TUELECTRIC

Log # TXX-92343
File # 916
Ref. # 10CFR50.36a

SUBJECT: COMANCHE PEAK STEAM ELECTRIC STATION (CPSES)
DOCKET NOS. 50-445 AND 50-446
TRANSMITTAL OF COMMENTS ON THE
PROOF AND REVIEW COMMON TECHNICAL SPECIFICATIONS

The proposed changes include; 1) corrections to validated Unit 2 values, 2) corrections reflecting previously transmitted changes, and 3) a revised testing frequency for turbine overspeed protection. Attachment 1 provides the descriptions/justifications for the proposed changes. Attachment 2 is a markup of the "Proof and Review" Technical Specifications denoting the proposed changes. Please note that Amendment 11 to the CPSES Unit 1 Technical Specifications have not been incorporated into the Proof and Review copy.

ATT Valve Testing Interval

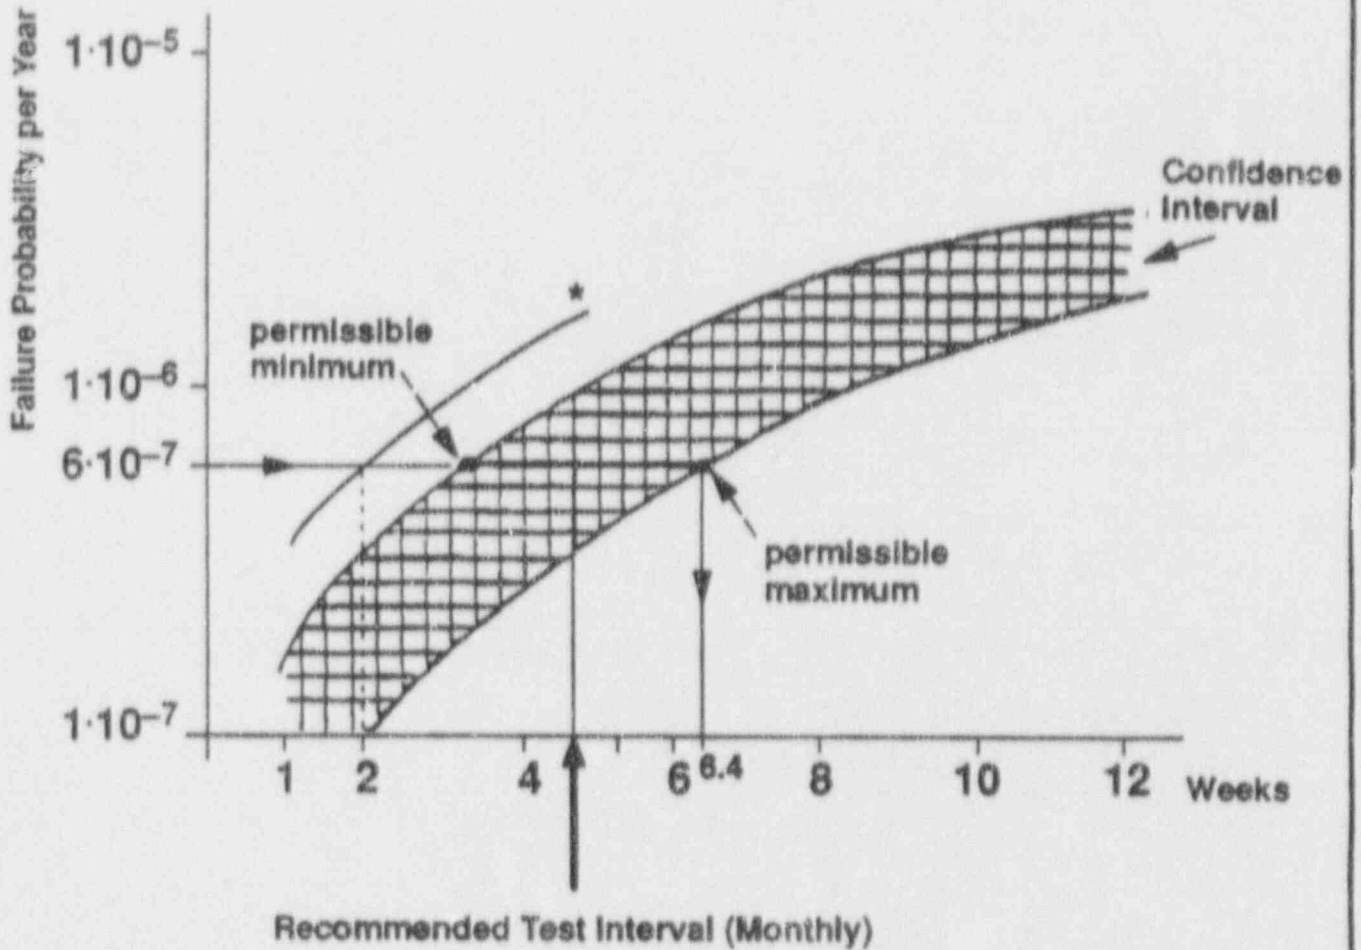
Siemens, the manufacturer of the CPSES turbines (Units 1 and 2), has recommended a one month testing interval, or a six week testing interval providing, that additional monitoring sensors are installed on each stop valve, and that no degradation of closing time is observed. This recommendation was based on a quantitative evaluation performed by Siemens on the probability of failure of the HP/LP turbine stop and control valves as a function of their test interval (see attached figure). CPSES intends to install the additional monitoring sensors and monitor valve closing time

In Engineering Report No. ER-504, previously submitted on the CPSES docket (FSAR Section 3.5, Reference 5), using a two week testing interval, and historical failure rate data gathered through January 1, 1975, the failure probability of HP/LP stop and control valves was calculated to be 3.93×10^{-6} and 8.53×10^{-6} per year respectively. Based on the above, the overall turbine missile probability was determined to be approximately 2.1×10^{-7} per year. Subsequently, Siemens re-evaluated the failure rate data for Siemens turbine stop and control valves using information gathered through 1984. The updated failure probability for these valves decreased to 6×10^{-7} per year. Based on the attached figure of valve failure probability versus testing interval, increasing the test interval to six weeks would not increase the failure rate of these valves to a level as high as that assumed in ER-504. Thus, the requested six week test interval would not increase the overall missile generation probability.

degradation prior to implementation of a six week testing interval.
